Case #H 93-24. 431 Arroyo Tenorio. Downtown/Eastside Historic District. Chapman Homes proposes window replacement; addition on east elevation. (Tabled by applicant prior to 2/22/93 meeting.)

City of Santa Fe, New Mexico

CASE #H- 93-24 ADDRESS 431 ARROYO TENORIO

RE: Case #93-24 / 431 Arroyo Tenorio

SOUTH ELEVATION

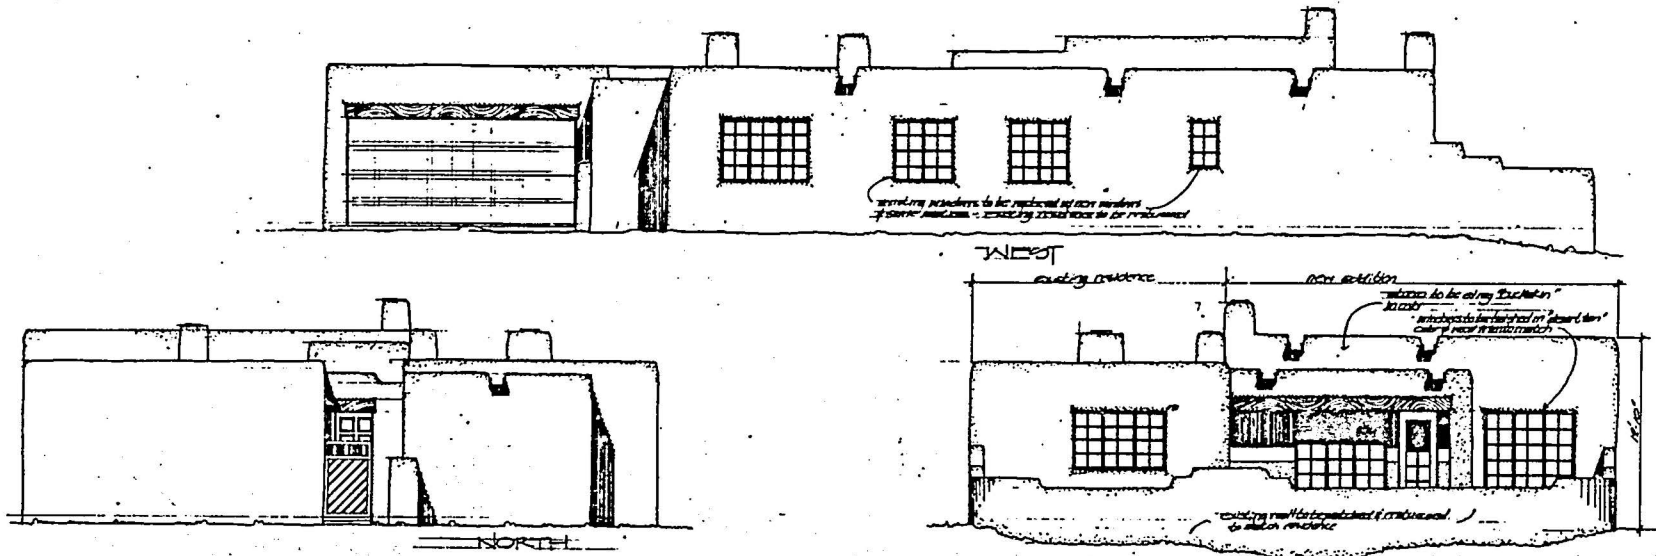
In order to accommodate the proposed use of the existing building, window and door patterning will be revised, resulting in some existing openings to be filled in and others to be enlarged and/or covered up by placement of the addition. The building's exposed vigas will be removed (violation of 14-70.2 (C) & (D), 14-70.4 (A) (1)).

Though not noted as to the architectural scale at which it is drawn, the proposed addition footprint appears to exceed 50% of the existing footprint. It does, in addition, exceed the height of the existing building by 1 ft. 10 inches (violation of 14-70.4 (B) (4), 14-70.4 (B) (5) (a),, 14-70.4 (E) (a), (b), and (c)).

431 Arroyo Tenorio
Existing structure
West Elevation

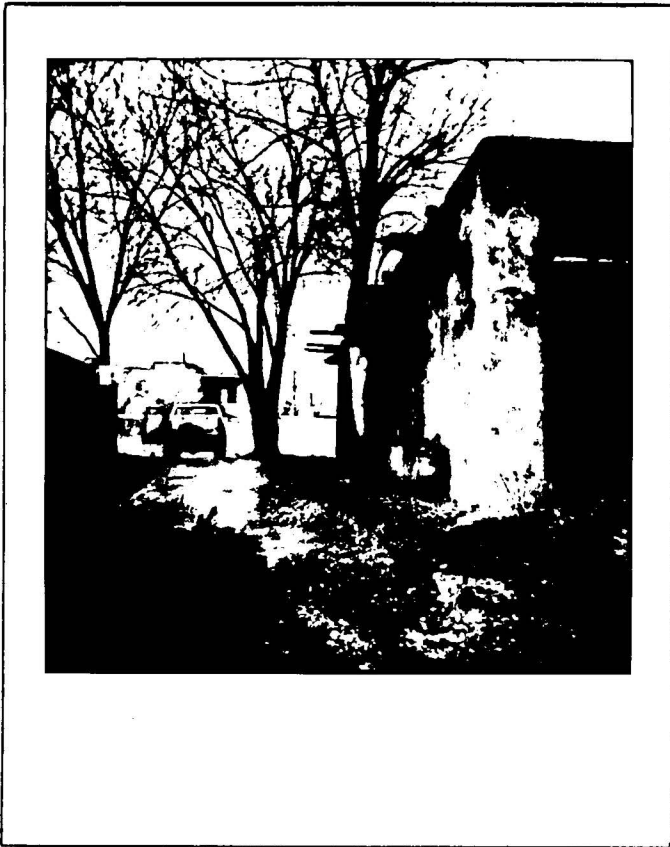
(ornamentation pattern altered/removed
projecting vigas removed)

431 Arroyo Tenorio
Existing Structure
East Elevation

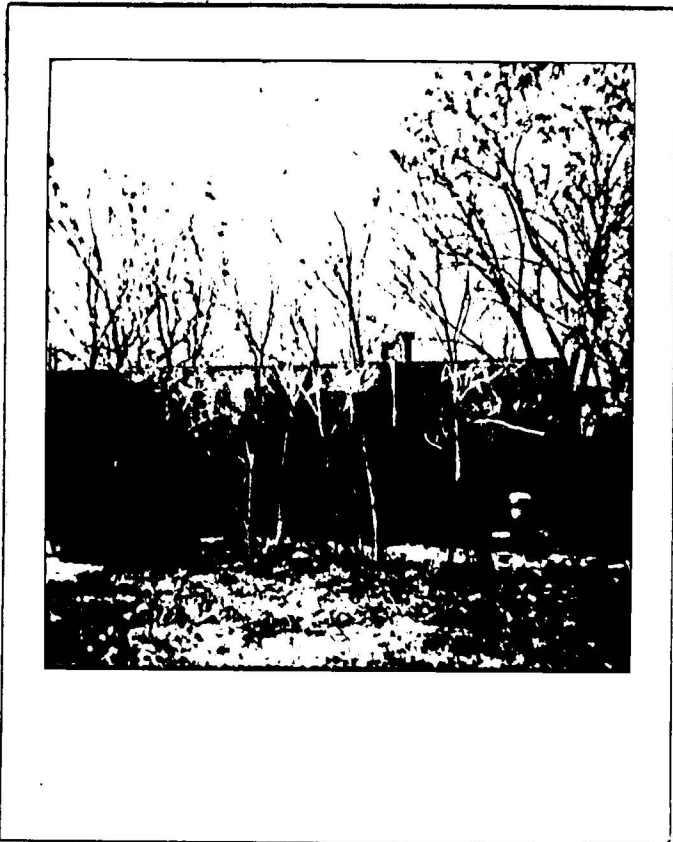
(addition placed on this elev.)

(elevation completely
obliterated by
addition)
